### MEMORANDUM

To: Development Review Board  
From: Mary O'Neil, AICP, Senior Planner *moniel*  
Date: August 20, 2013  
RE: ZP 13-1240CA/CU and ZP 13-1241 CA/CU; 78  
and 80 Sherman Street

**Request:** Demolish two existing single family homes (on separate lots), reconstruct new single family residences.

79 SHERMAN

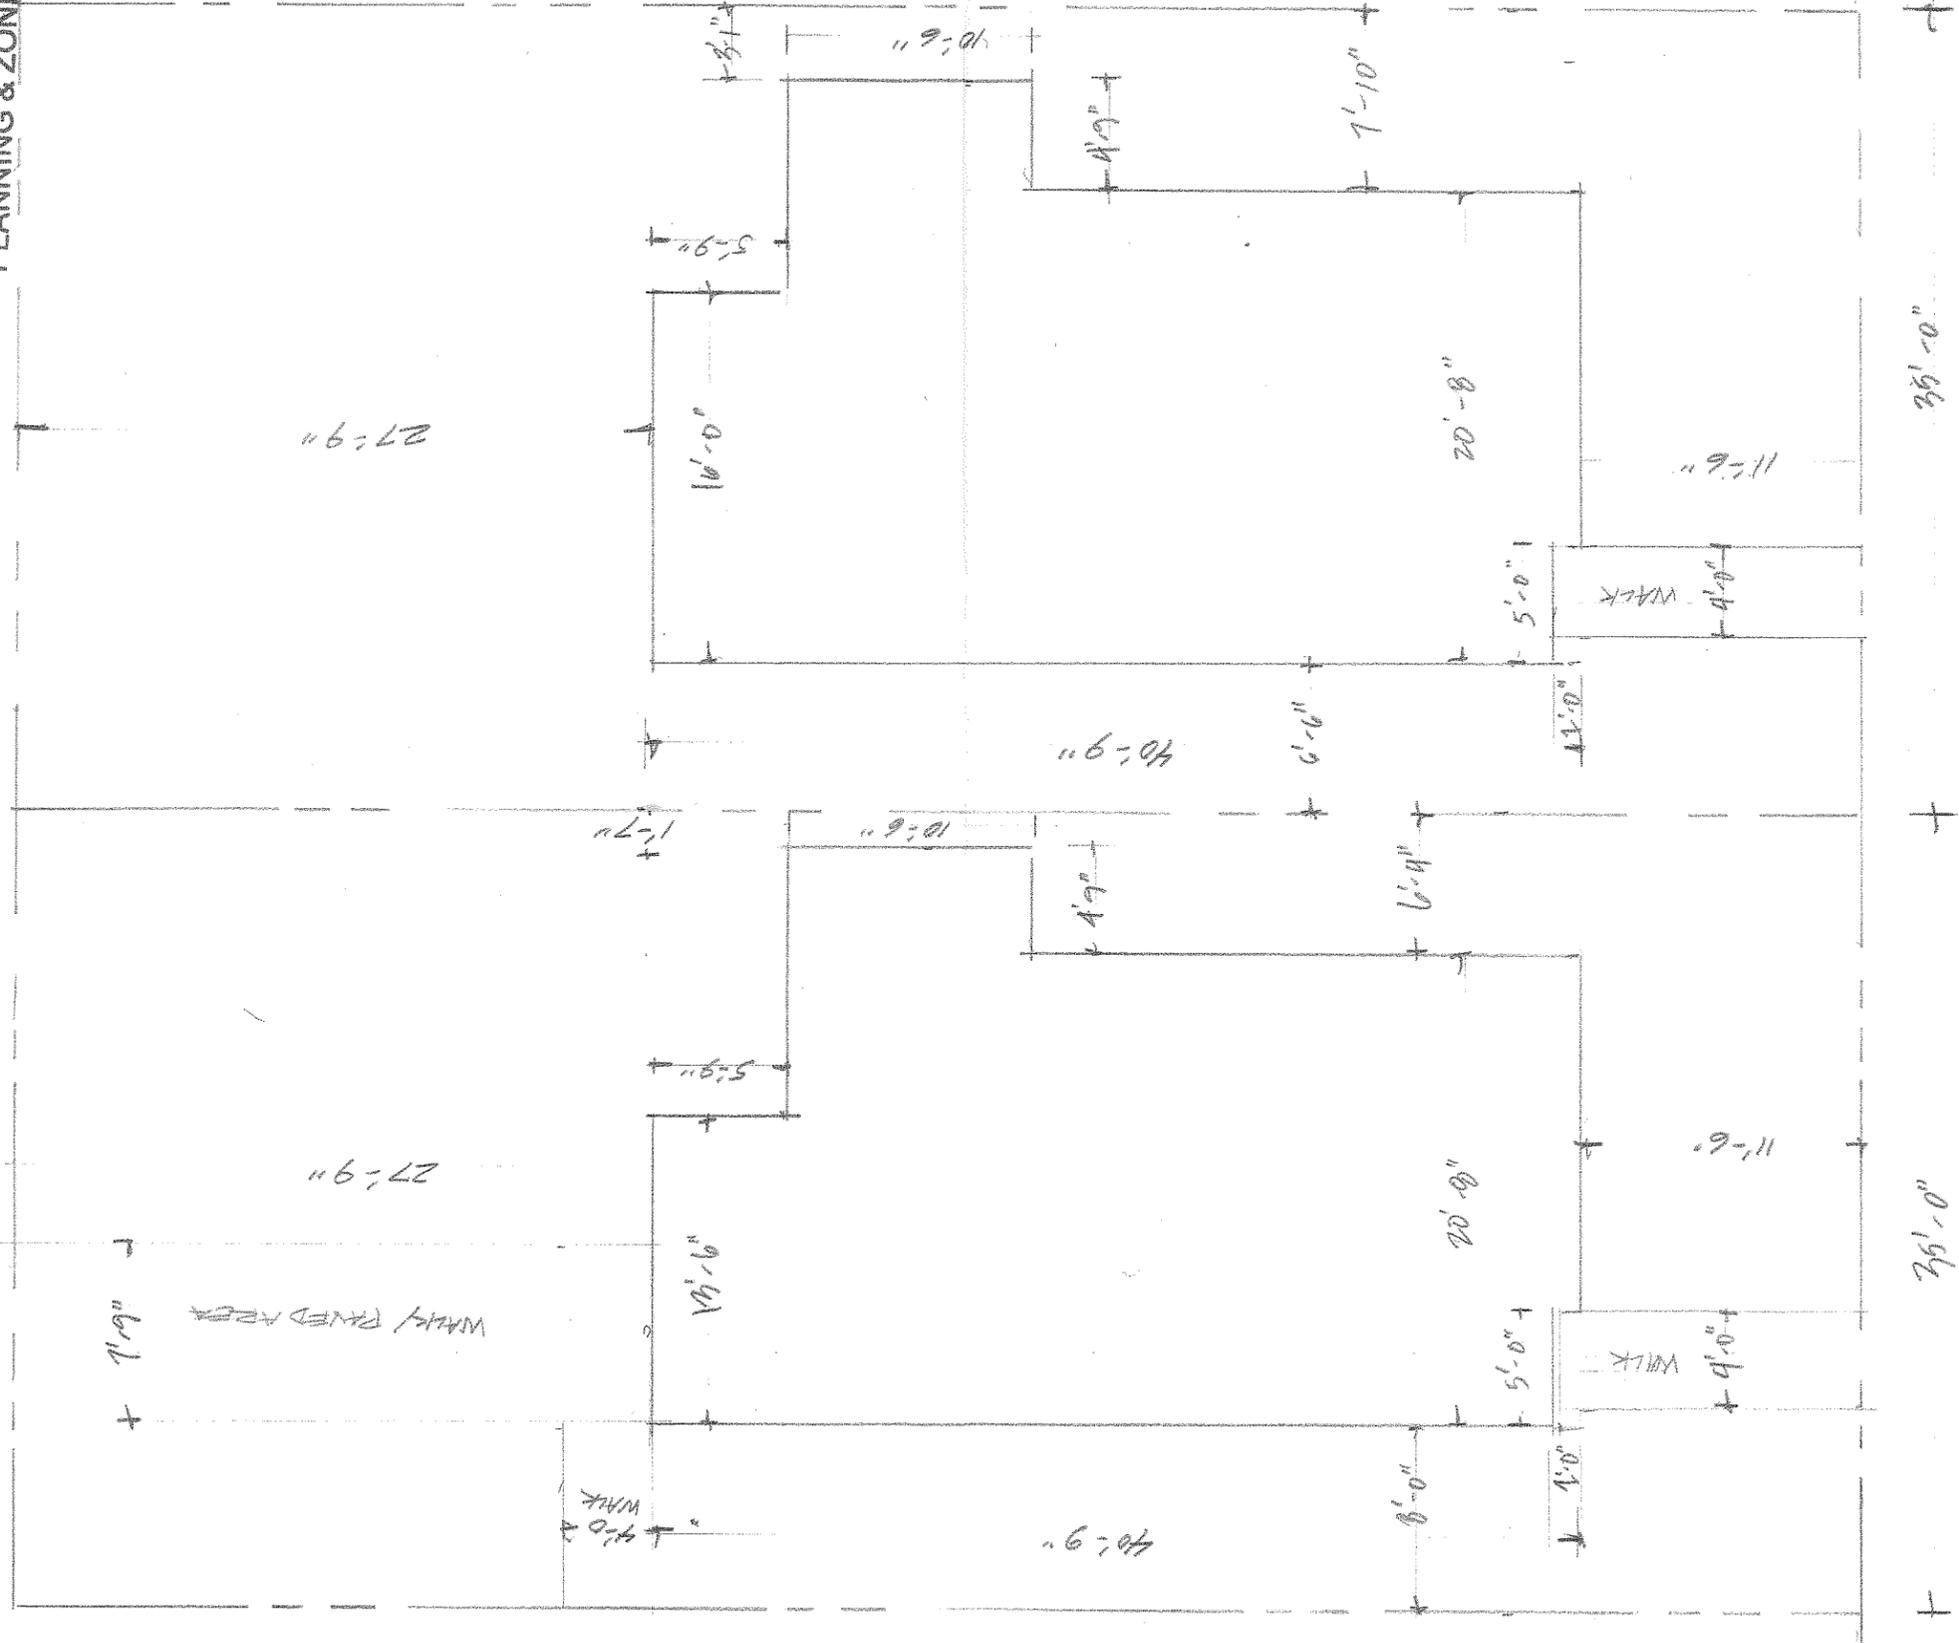
78 Sherman Street	Existing: 40.91% Proposed: 39.14%	No change	Existing: 1'7" east, 8' west (non- conforming) Proposed: 5' east, 8' west.	Parking abuts property line. Structure set back 29.5' existing; 27.75' proposed.	Approximately 22'
80 Sherman Street	Existing: 32.6% Proposed: 34.32%	No change.	Existing: 3'1" east, 6'6" west. (non- conforming) Proposed: 8' east, 5' west.  (25% = 20')	Existing: 27'9" Proposed: 29'6".  (25% = 20')	Approximately 22'

PROPOSED  
 80 SHERMAN ST.

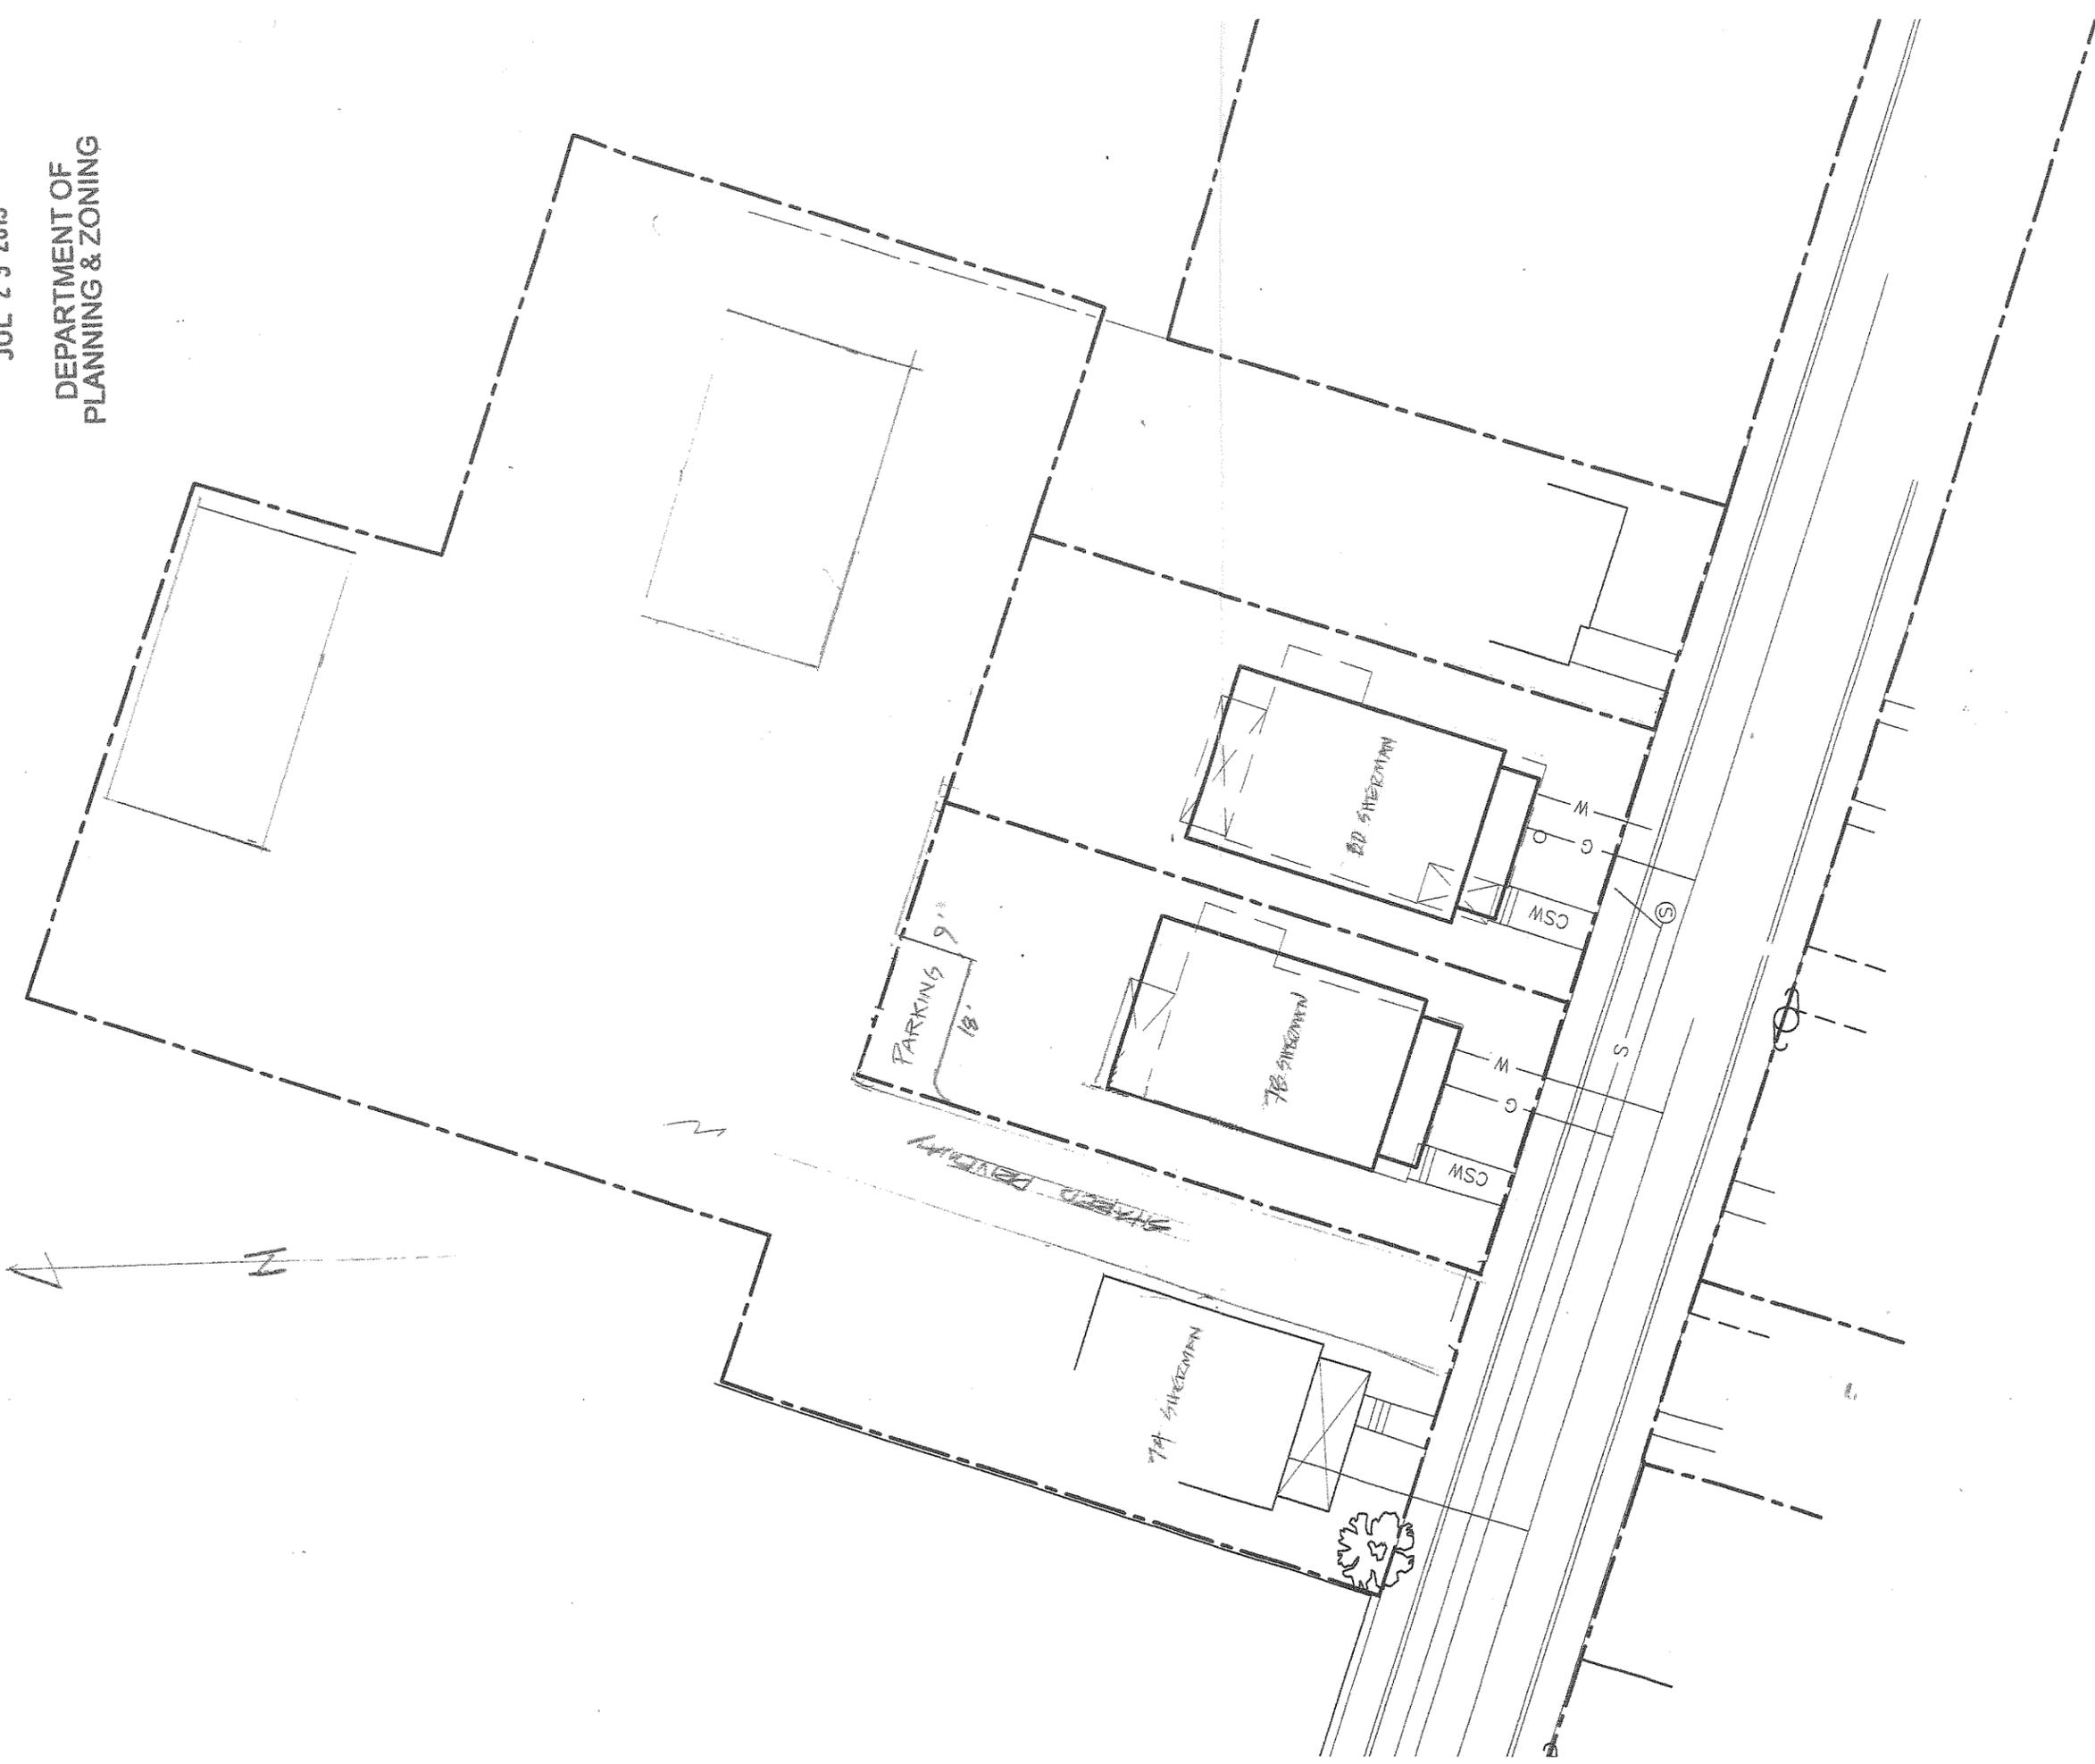
Front walkways are proposed for both single family homes. Rear walkways (toward the rear of 74 Sherman Street lot) are illustrated on the site plans. A pedestrian walkway is understandable as residents will wish to walk to their parking space.

The submitted proposed site plan show both existing trees (white birch, lilacs, maples) and proposed (Japanese Roses.) Shrubs around the porch and trash enclosure have not been identified, and should be well thought-out prior to advancing to the DRB. The DAB has requested a comprehensive landscaping plan. **Affirmative finding as conditioned.**

As submitted, trash cans are illustrated on a site plan adjacent to the rear property line. Assumably this is for proximity to the rear lot where other trash is located? Perhaps an agreement could be reached to share a dumpster/recycling location on the rear of 74 Sherman Street for all three parcels to enjoy. Conversely, a separate location on-site would be required that meets this standard – *enclosed on all four sides*. **Affirmative finding as conditioned.**

6. The applicant shall provide lighting specs prior to advancement to the DRB.
7. Any signage will require a separate sign permit.
8. The applicant shall submit a more robust landscaping plan for the post-construction sites. Special attention shall be paid to the effects of headlight glare from the rear parking area, and screening for rubbish storage.
